**INFO-TECH** CITROËN Racing C2 R2 MAX N° 23/09.

**Subject:** Gearbox bracket.

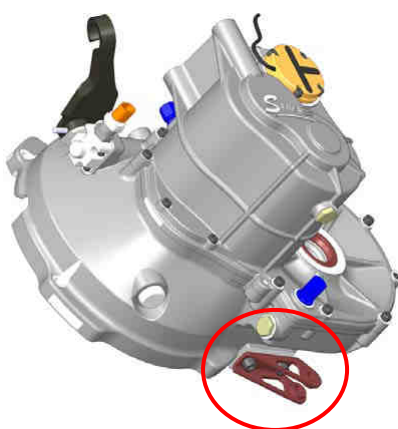
We ask you to pay attention about the loosening of the gearbox anti torque bracket.

The loosening of this bracket may create a dangerous engine movement (around engine and gearbox mountings) and damage the gearbox body and the bracket.

We recommend you to check the bracket tightening in accordance with gearbox SADEV notice sheet (loctite 243, torque 5.5 DaN.m).
